WATER LICENCE INSPECTION FORM

Hamlet of Qikiqtarjuaq				Phillip Sanguy	/a					
Licence No. / Expiry				Representa						
3BM-QIK1417			Senior	Senior Administrative Officer and Hamlet						
				Forem	Foreman					
Land / Other Authorizations				Land / Other Authorizations						
Date of Inspection			Inspector							
August 15 2014 A. Keim										
Activities Inspected Camp	☐ Drilling		☐ Mining ☐ Construction ☐			Reclamation	П Еце	l Storage	2	
Roads/Hauling		ater Discha			ner: Munic	ipality	Recialitation		a storage	<i>,</i>
Conditions: A -	Assentable		C - Concern	II IImaaaan	tabla	NΙΔ	Not Applicable	NII N	lot Inc	nostod
Water Use	Acceptable		Site Condition	U - Unaccep			Not Applicable			pected
Intake/Screen	A	Comment	Water Managen		Condition	Comment	Haz/Mat Manag		Condition	Comment
			, and the second		NA		Storage Spills		C	1
				Culverts / Bridges			Spill Plan			1
Source: Tulugak River Water Use: 11,978,35			Drainage (Coalling and		NA NA		Spili Piari		Ą

Figure 14 Chlorination system

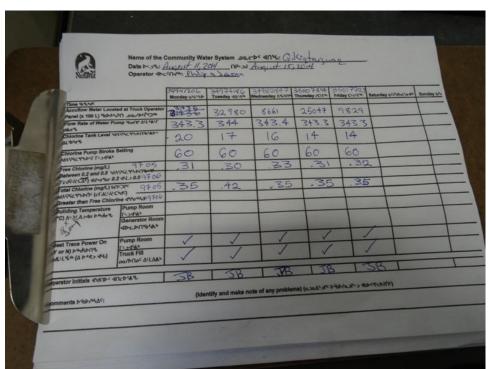
The transfer station was found in fair condition however it was again noted that the filters are not being used in the last three years. Chlorination and other records were found on site and in order. The chlorination system was functioning and in good repair.
